# TCM-S63/S64V/S65/S66V

## SONY. SERVICE MANUAL

### SUPPLEMENT-1

**Subject : Change of REC/PB Head**

Page 11

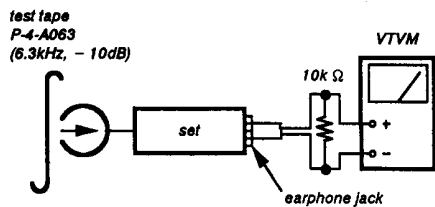
Former			New		
<u>Ref. No.</u>	<u>Part No.</u>	<u>Description</u>	<u>Ref. No.</u>	<u>Part No.</u>	<u>Description</u>
108	3-385-721-01	GUIDE, HEAD	108	<u>3-907-591-01</u>	GUIDE, HEAD
109	3-385-723-01	SCREW	109	<u>3-907-592-01</u>	SCREW
123	_____		123	<u>3-907-593-01</u>	WASHER
124	_____		124	<u>3-907-594-01</u>	SPRING
HRP901 1-543-607-21 HEAD, MAGNETIC (REC/PB)			HRP901 <u>1-543-410-11</u> HEAD, MAGNETIC (REC/PB)

The record/playback head azimuth adjustment is requested due to this change.

### Record/playback Head Azimuth Adjustment

#### Procedure :

1. Mode : Playback

2. Turn the adjustment screw to obtain the maximum reading on VTVM.

**Note :** Several peaks may appear, but take the maximum.

3. After the adjustment, lock the adjustment screw with suitable locking compound.
